TO: Mercedes-Benz Dealer Principals, General Managers, Sales Managers, Service Managers, Parts Managers	FROM: Gregory Gunther, Department Manager, Vehicle Compliance and Analysis, Engineering Services
RE: Emission Modification Notification – [[2020050025]] MY 12 R350 BlueTec 4MATIC Update – Emission Modification Category (EMC) #5	DATE: January 13, 2022

Campaign No. 2020050025, January 2022

SUBJECT: **Model R-Class diesel vehicles (V251 platform)**
Model Year 2012
Modification to the emission control system

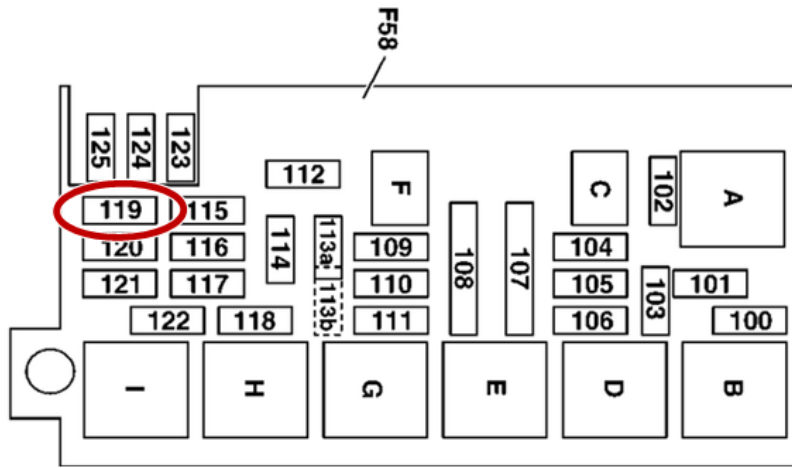
6. Replace the injector of the exhaust after-treatment system (A 164 490 26 00 80).

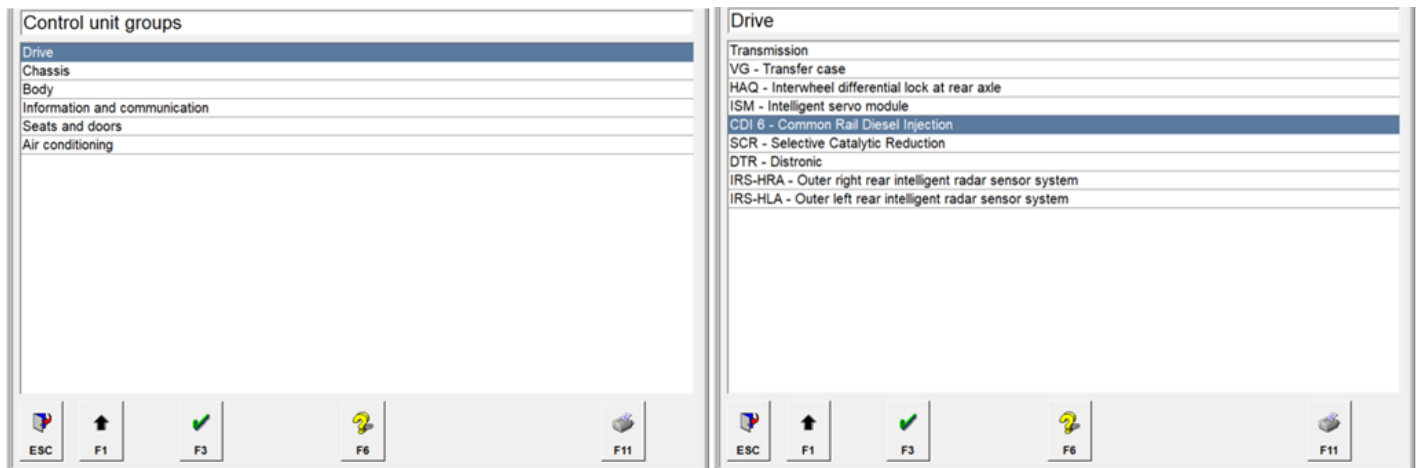
8. Check fuse **F119** for presence in the fuse and relay box (F58) in the engine compartment on the right and remove if necessary.

i If this fuse is plugged in, it must be removed before the software update. The fuse must not be plugged in again and has to be disposed.

Figure 6

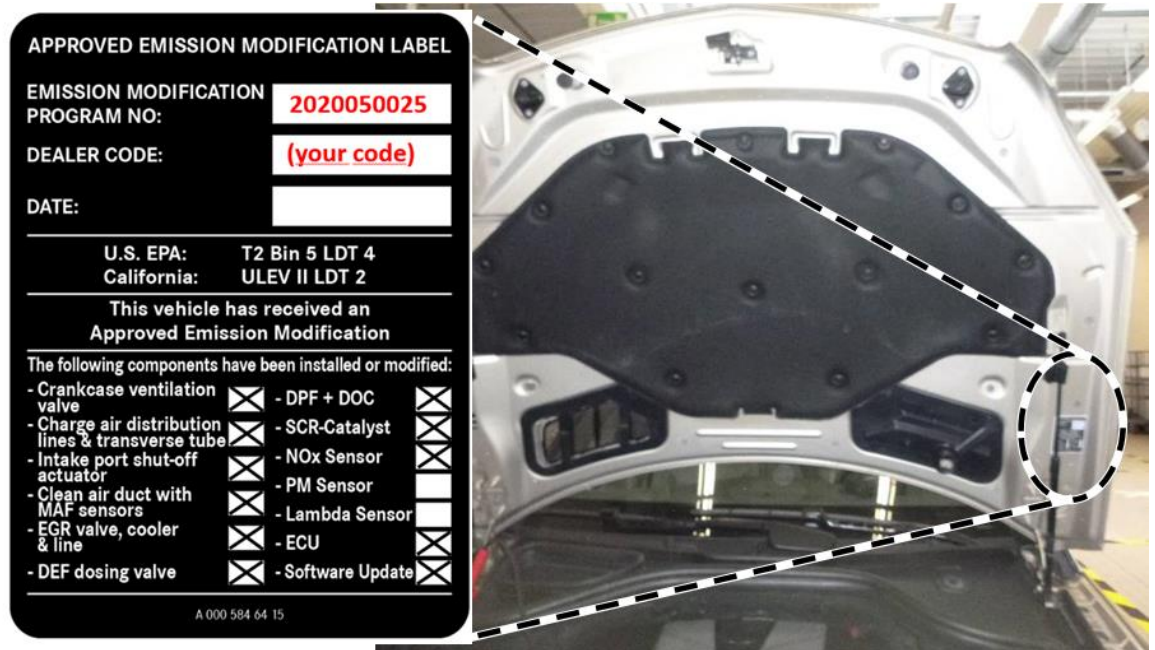
12. Clean the bonding surface of the hood and attach the adhesive label (A 000 584 64 15) **(Figure 6)**.

- i** The fields on the adhesive label must be filled out correctly. Please use black permanent marker. Refer to **(Figure 6)** within the XENTRY procedure.
- i** The adhesive label can be applied to the hood **while** updating the software for the engine control unit.
- i** Failure to comply may result in dealer debit and/or possible fines.
